Report / Decision on Change or Cancellation of Condition(s)

s127 Application Number:	RMA/2022/927/B
Original application number:	RMA/2022/927
Applicant:	Sovereign Palms Limited
Site address:	31 Hawkins, 47 Hawkins Road and 1 Selkirk Place, and 11 Selkirk Place
Legal Description:	Lot 4000 DP 569920 Lots 4, 5 DP 23089, Lot 2 DP 512441 Lot 6 DP 23089
Zoning:	District Plan: Residential New Neighbourhood PC14: Future Urban Zone
Overlays and map notations:	District Plan: Outline Development Plan (Highfield Park (North)); Liquefaction Management Area (LMA); Environmental Asset Waterway (Horners Drain located at east side of Hawkins Road) PC14: n/a
Activity Status:	Discretionary activity
Description of Application:	Change of conditions pursuant to Section 127

Section 133A Amendment

8.3 Existing Road Frontage - lots 197 and 198

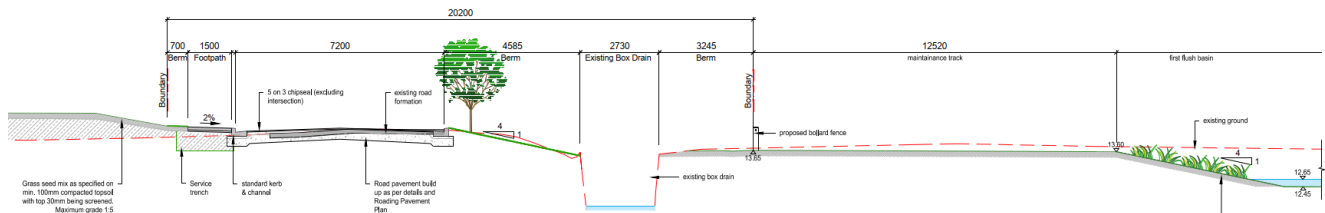
The proposed changes to condition 8.3 are in **bold and underlined**:

Hawkins Road frontage to lots 197 and 198 shall be upgraded at the cost of the consent holder to include 1.5 metre shared path, kerb and channel on the west side of Hawkins Road, undergrounding of services and seal widening to achieve an ~~an~~ & 7.2 metre carriageway. Lighting will be reviewed and upgraded if required.

Typical Cross-Section - Hawkins Road '3-3'
Scale 1 in 100

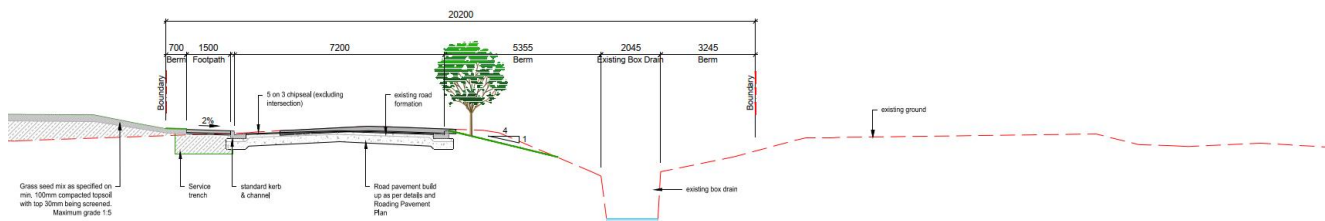
The applicant seeks to vary this condition to provide for a safer and more efficient road layout. Following a site walk over with Council's Subdivision Engineer, Mr Doru Hozias' attention was drawn to the proposed kerb and channel location on the eastern side of the Hawkins being too close to the drain. Discussions were held and agreement from Roading Engineer Mr Weng-Kei Chen to amend the road cross section to those shown below.

The change to condition 8.3 is to allow for a narrower carriageway width, and relying on Mr Chen's input I consider that change will have no adverse effects on any persons or the environment, for the following reasons:

- The applicant assessed that the operability of the road will not change as a result of the proposal. During a site walkover with Council's Subdivision Engineer, Doru Hozias, it came to the applicant's attention that the proposed kerb and channel location on the eastern side of the road is too close to the existing drain.

- Mr Chen commented that this problem was understood and expected, and that for the upgrades to work the following changes would be required:
 - o The proposed street trees along the frontage will need to be removed to allow the carriageway to be shifted westward;

- o The carriageway width be reduced to 7.2m wide from kerb to kerb; and
 - o Street trees be located along the bank of drain (east side of the road).
- Mr Chen's comment was that the 7.2m width is still an acceptable carriageway width for a local road and would comply with the District Plan standards. The proposed change is required to accommodate the conflicts arising from the site.
